## Certificate of Appropriateness

2205 – 2207 N. LAKE DR. North Point South HD

PTS ID 114745 COA: HVAC work

Visible A/C unit at NW corner

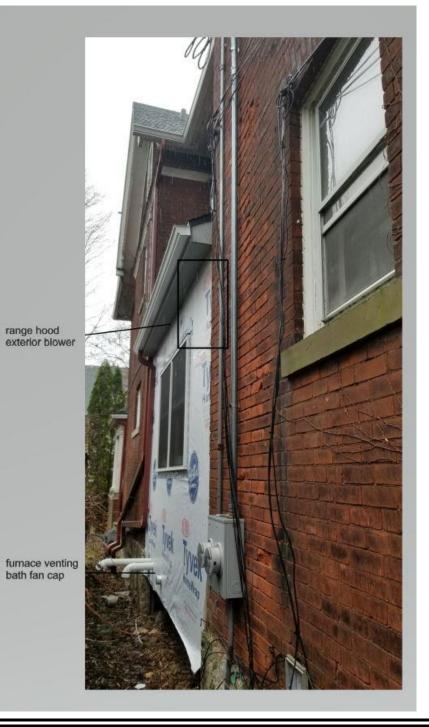
All equipment is to be installed precisely where indicated. Equipment physically on the house shall be painted or factory-finished to match surrounding building materials.

Install painted wooden fence or shrubberies to hide a/c condenser units from street view.
